# HIGHLAND PLANNING COMMISSION AGENDA

# PLANNING COMMISSION AGENDA REPORT ITEM #3a

**DATE:** August 26, 2025  
**TO:** Planning Commission  
**FROM:** Rob Patterson, City Attorney/Planning & Zoning Administrator  
**SUBJECT:** Highland Town Plaza Lot 3 Site Plan and Architecture Review  
**TYPE:** Land Use (Administrative)

1. Highland Town Plaza - Lot 3 - Review Comments - 2025.08.21 (Stipulation)
2. Project Narrative
3. 1. Highland Town Plaza Lot 3\_Site Plan
4. 2. Highland Town Plaza Lot 3\_Landscape
5. 3. Highland Town Plaza Lot 3\_Building Elevations and Details
6. 4. Highland Mo'Bettahs TGS 20250328 Signed

601

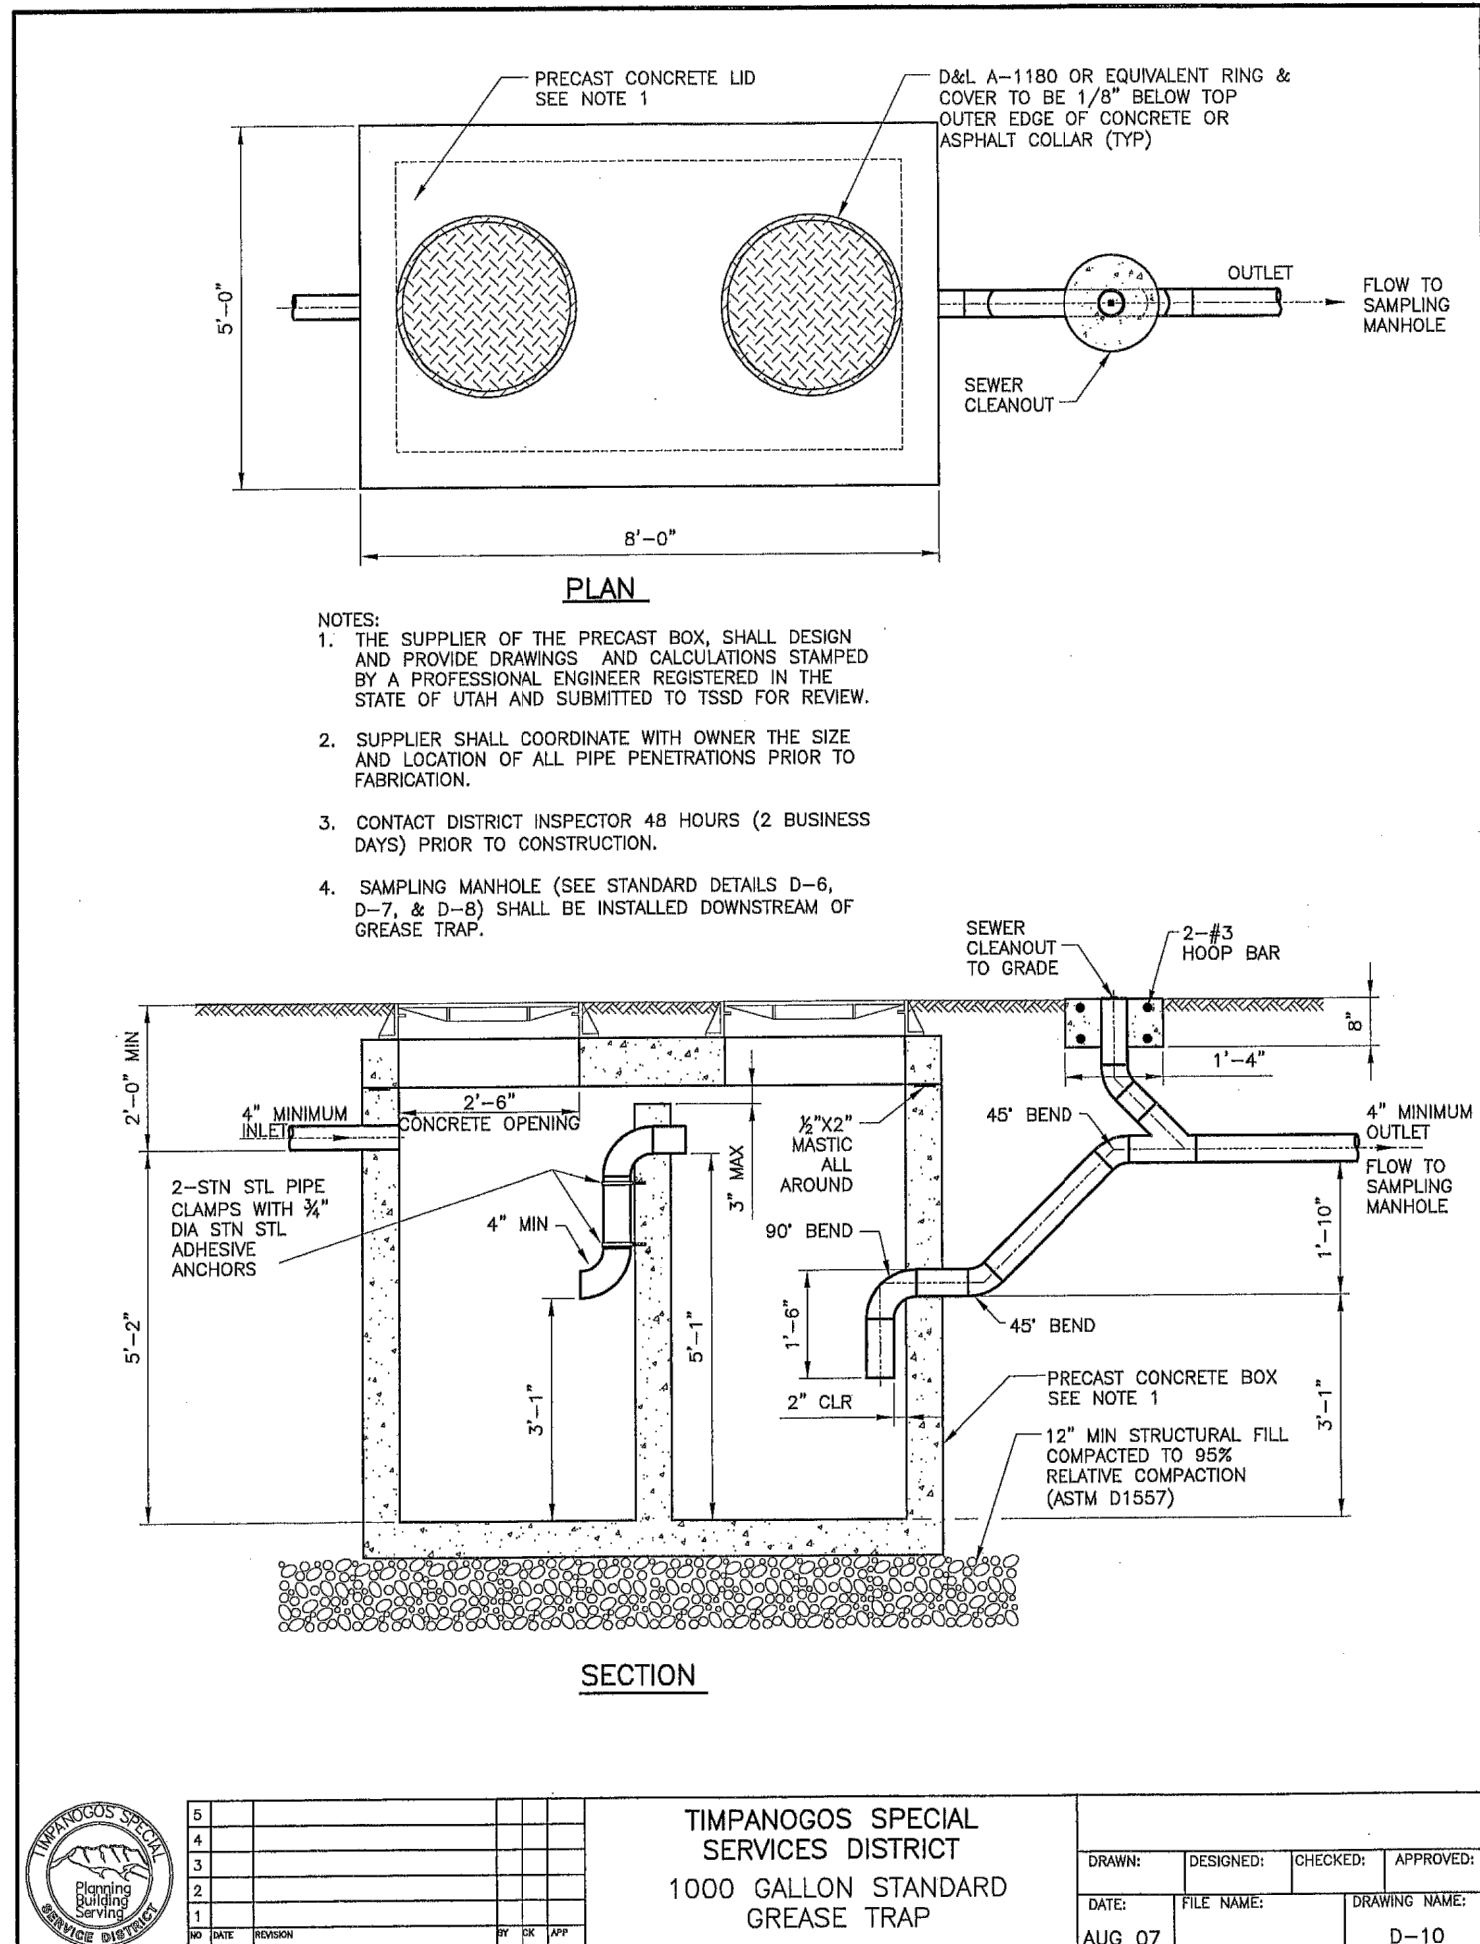
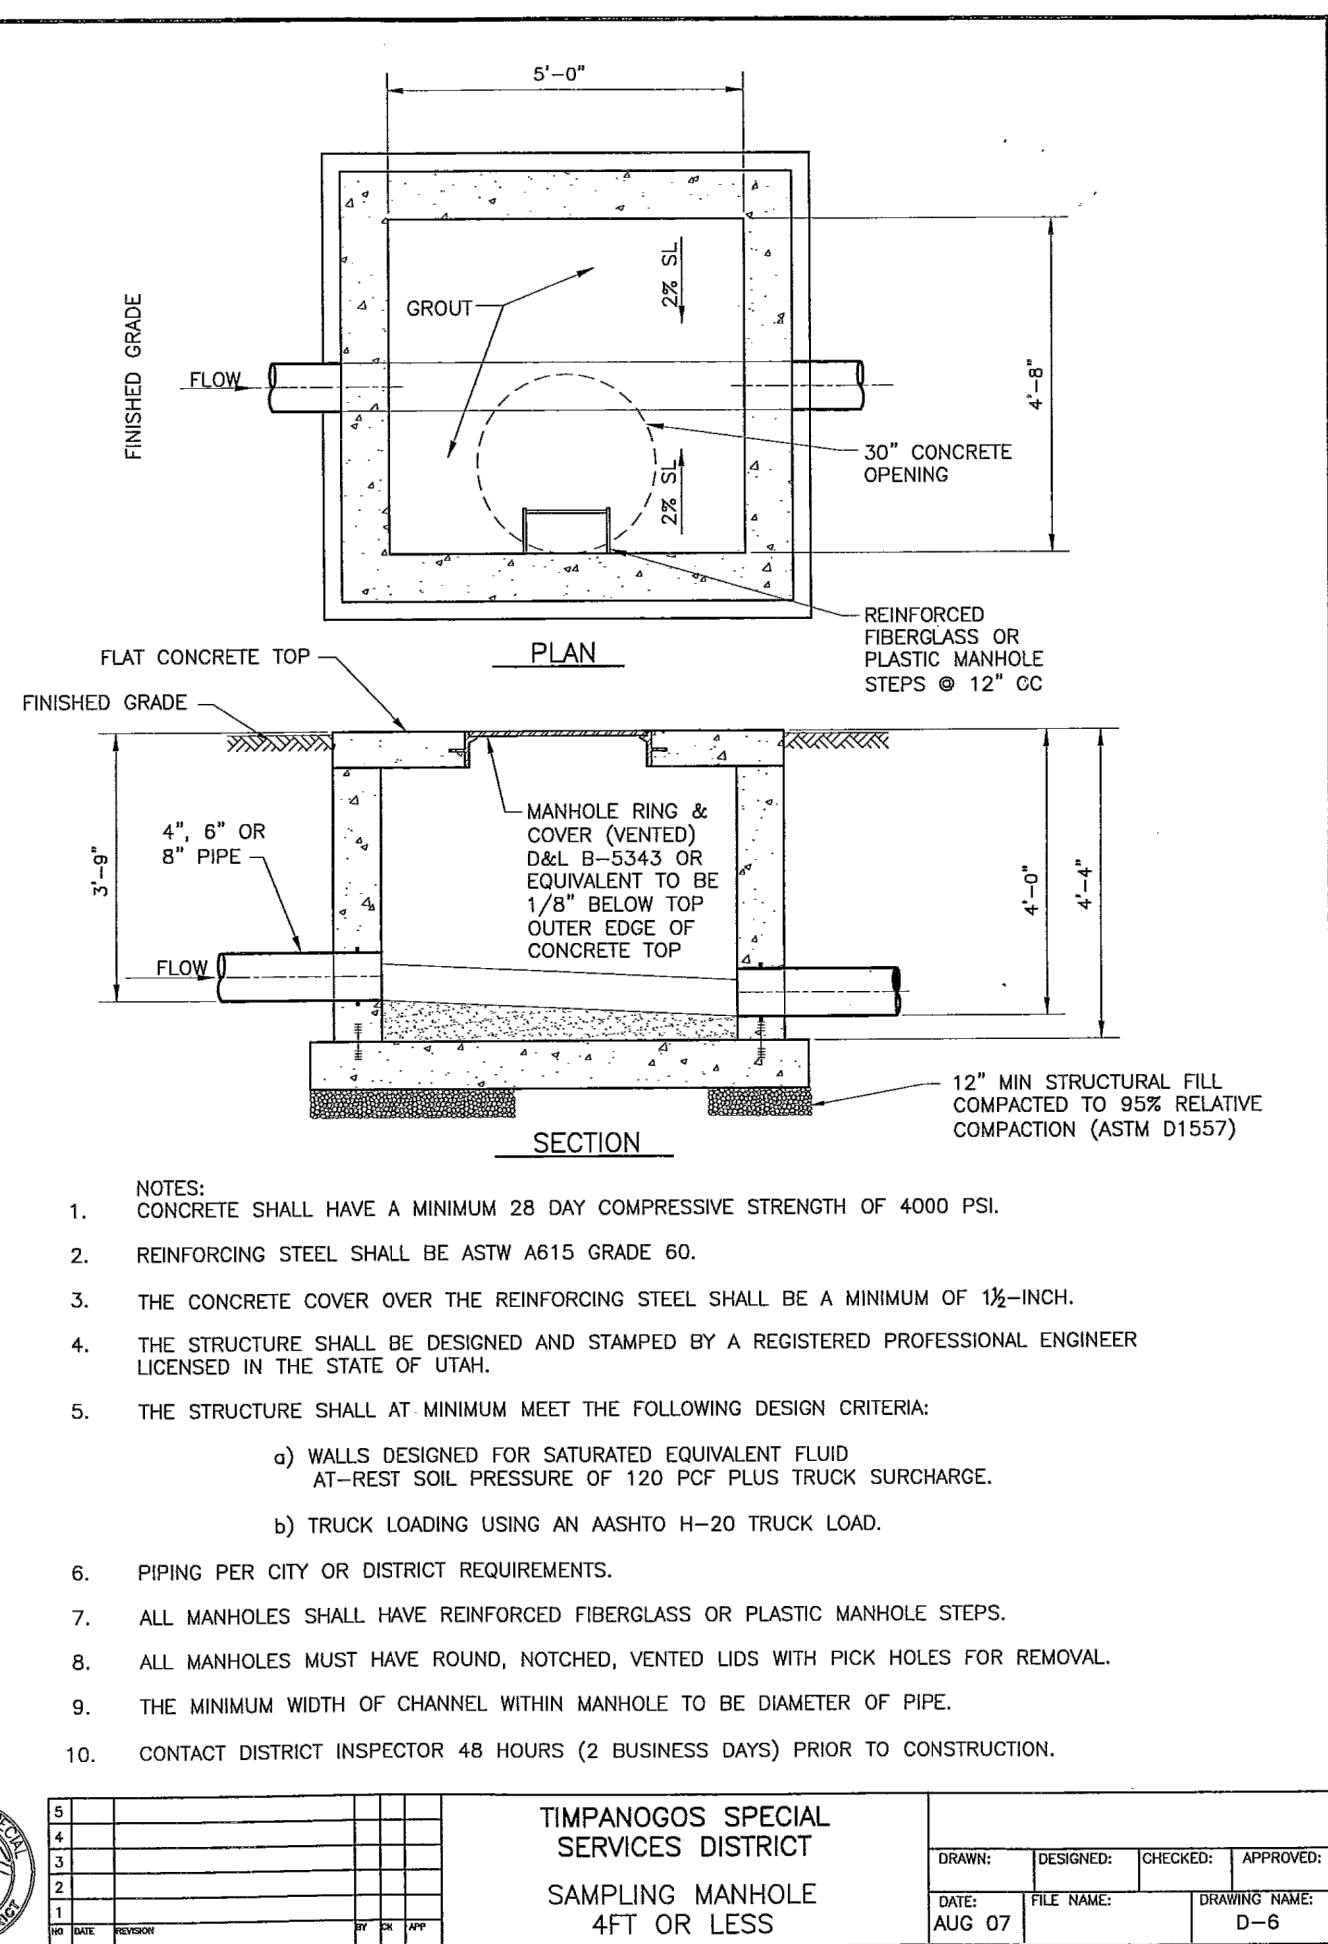
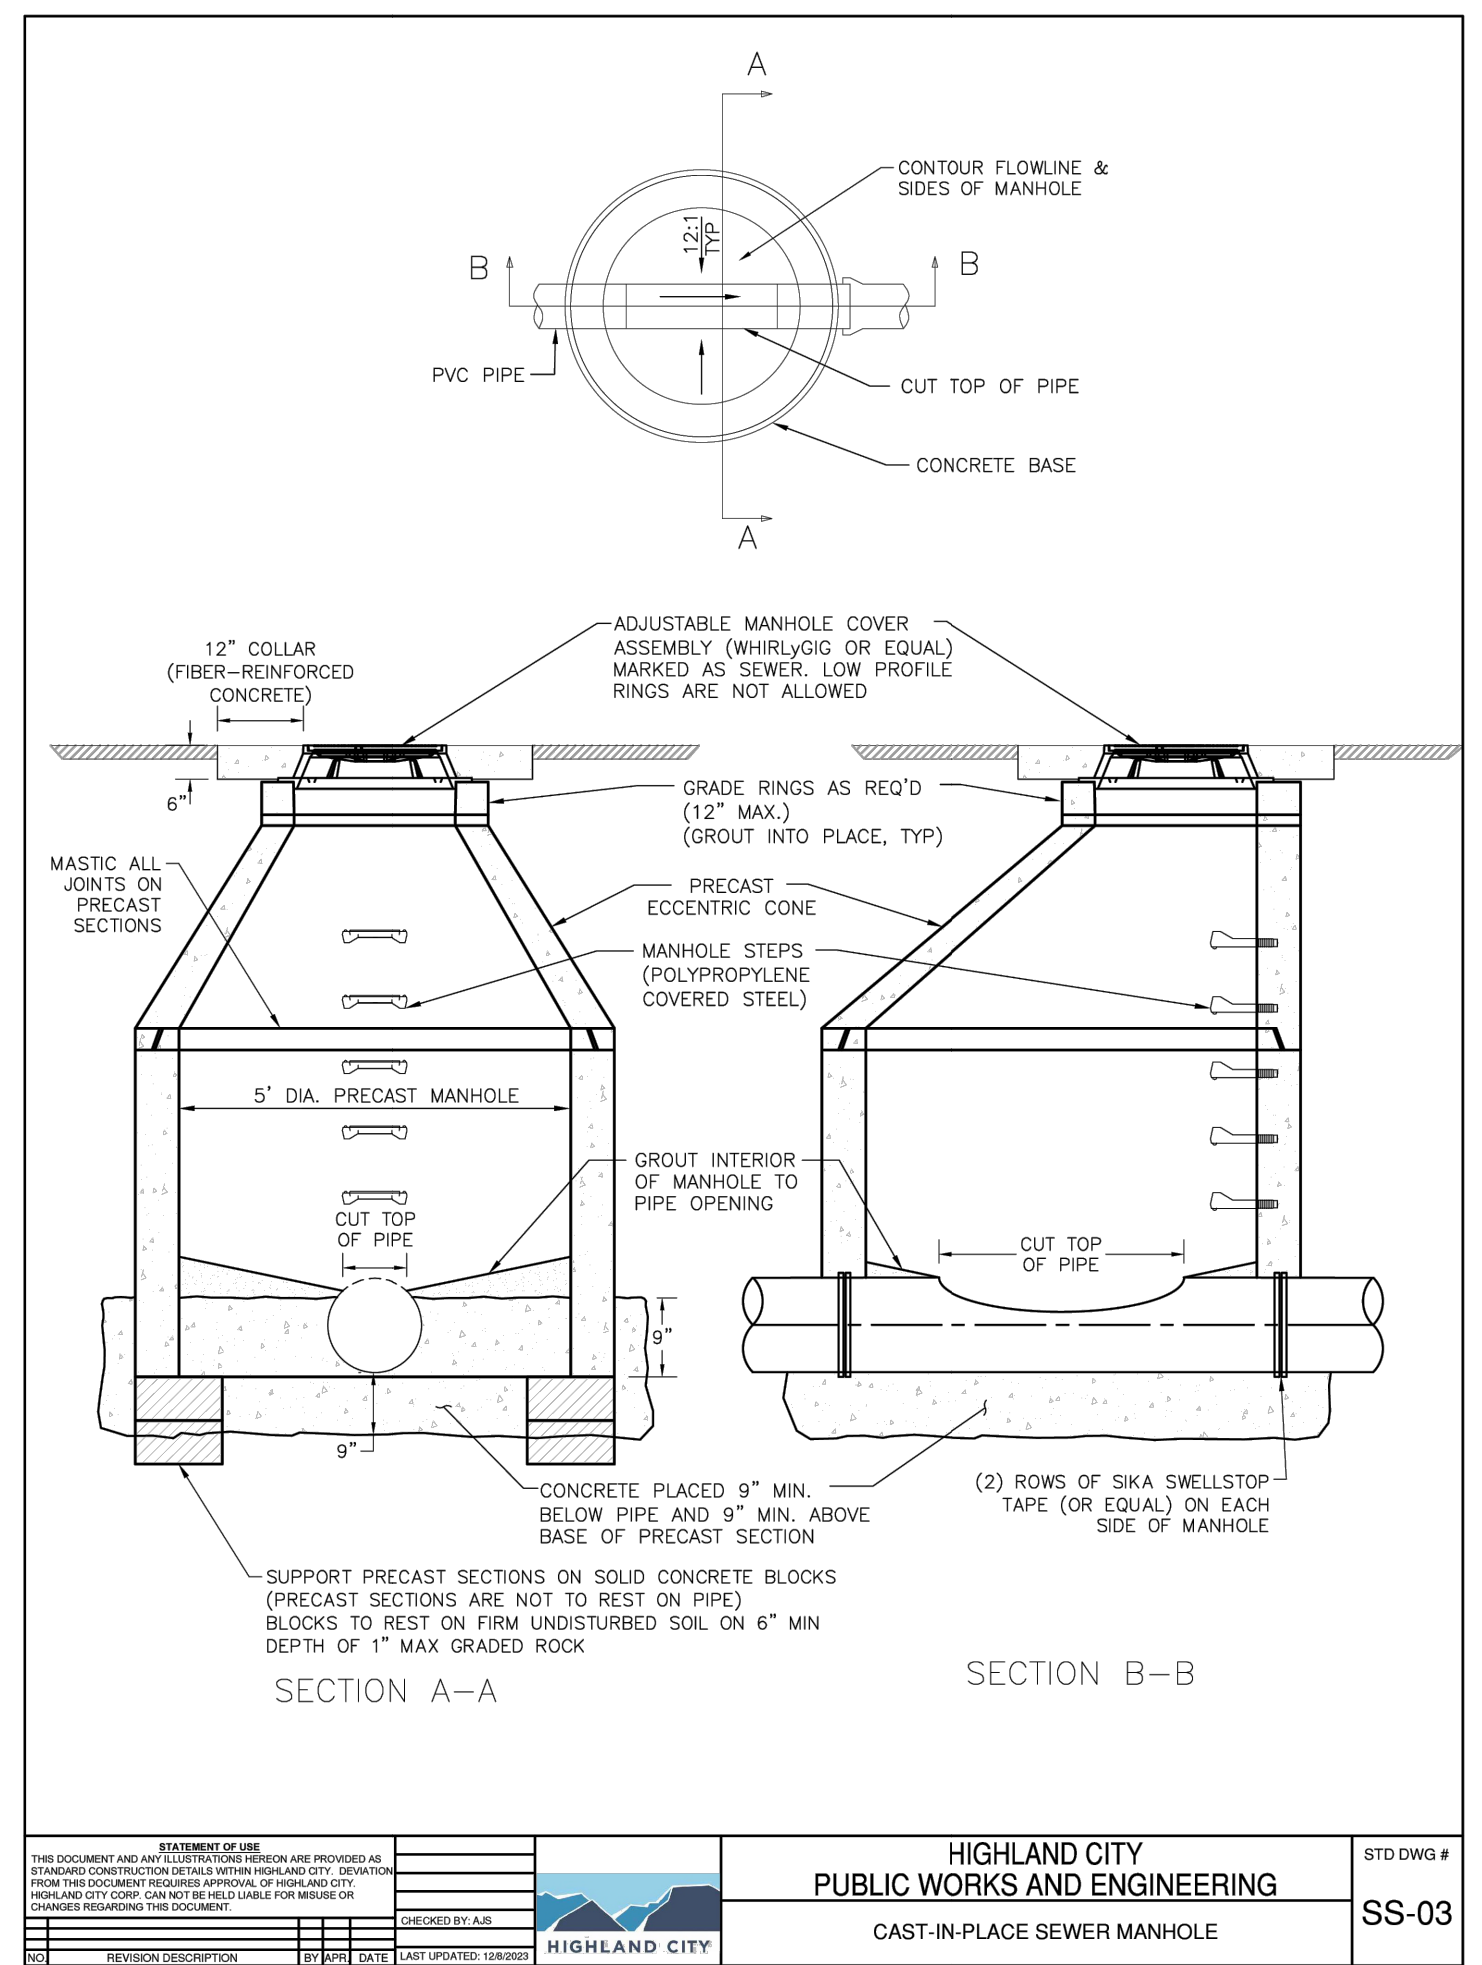
**Sheet 601-602 (Details):**

- 15. Consider providing full sheets for SD system details.
  - a. A full sheet of the SD system construction details is recommended.
